REQUEST FOR INFORMATION **DATE:** November 21, 2016 **NO.:** RFI-358

Project Name: 15051-Webster University Interdisciplinary Science Building

Subject: Door 160A Opening

A0101.B

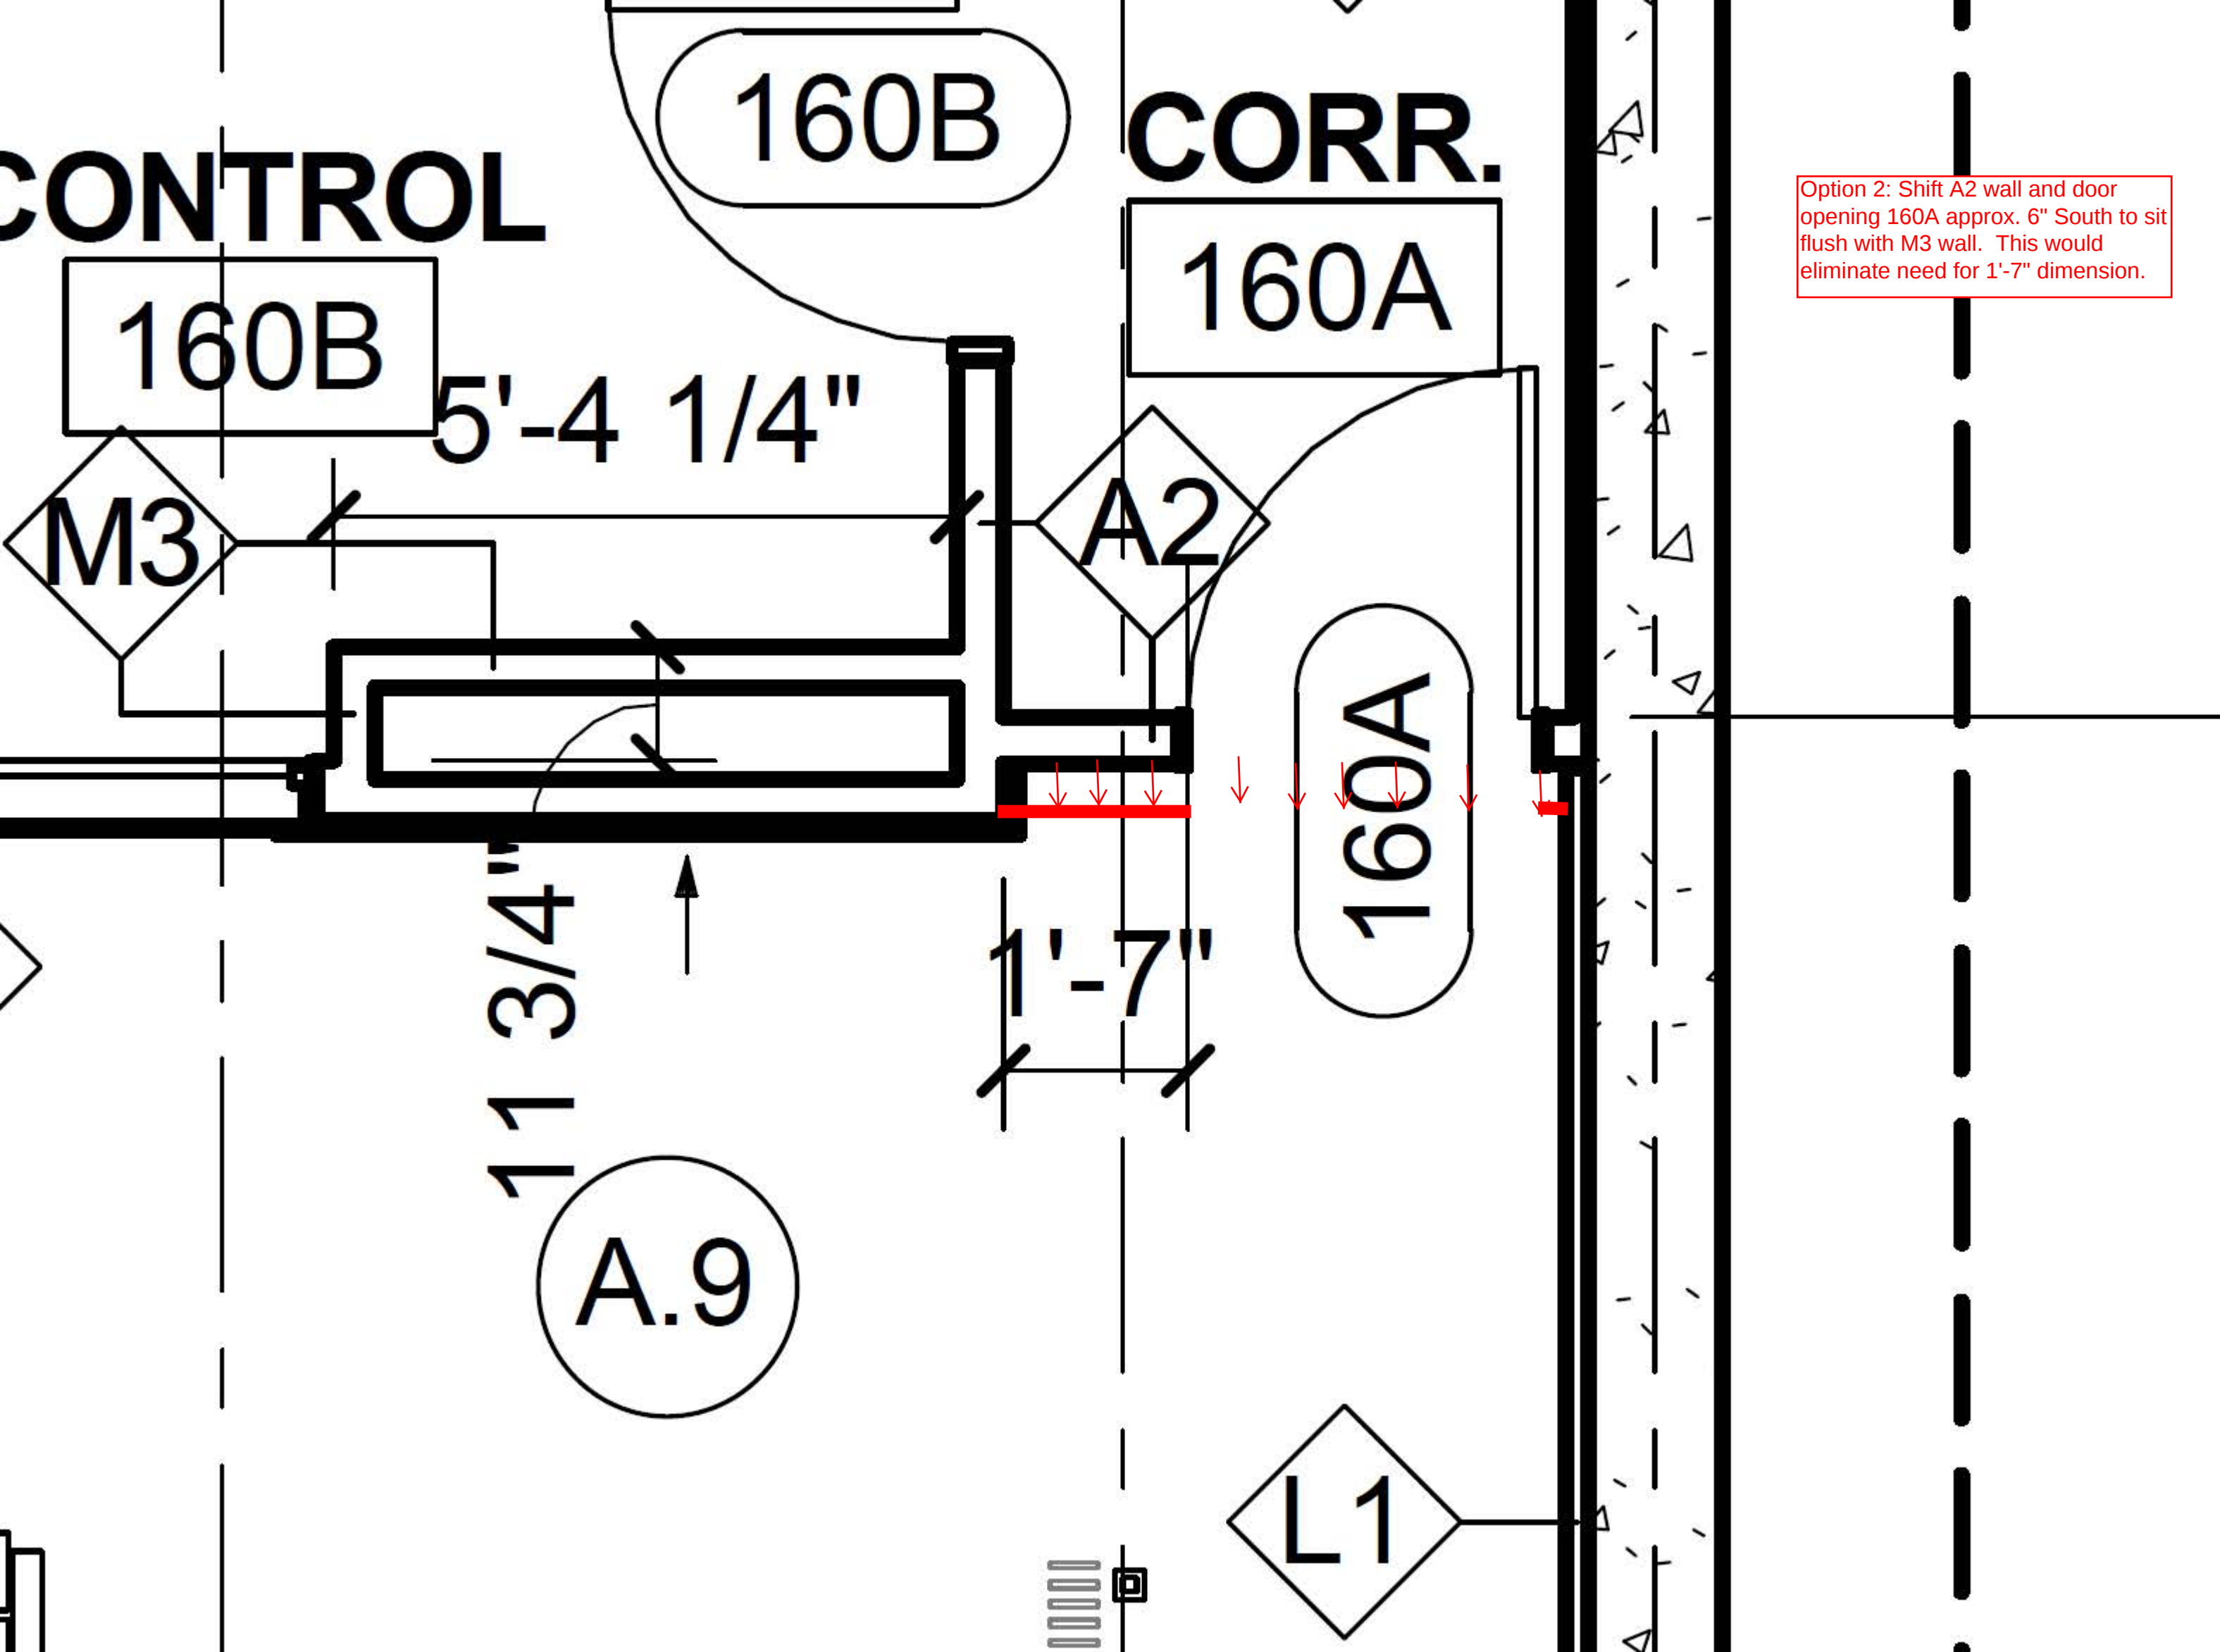
Sheet A0101.B shows a 1'-7" dimension from West edge of 160A opening to M3 wall. This dimension cannot be achieved by holding the door tight to the concrete wall as indicated in the drawings. We propose two options for this solution. See below.

- Option 1 – Allow for 1'-7" dimension to become 1'-3".
- Option 2 – Shift A2 wall and door opening 160A approximately 6" South to sit flush with M3 wall. This would eliminate the 1'-7" clearance issue.

Please advise on which option to pursue as we are currently framing walls in this area.

Option 1: Allow for dimension to be 1'-3" ILO 1'-7".

Option 2: Shift A2 wall and door opening 160A approx. 6" South to sit flush with M3 wall. This would eliminate need for 1'-7" dimension.

Provide dimension from face of conc. wall to Col. Line 4.5 and from 4.5 to 'A2' wall.

If needed, partition wall A2 with door 160B (parallel to col. line 4.5) can be adjusted, verify if it affects any MEP items.

Maintain min. 18" ADA required clearance from A2 wall at door 160A.

Please explain why the dimensions cannot be achieved per documents.
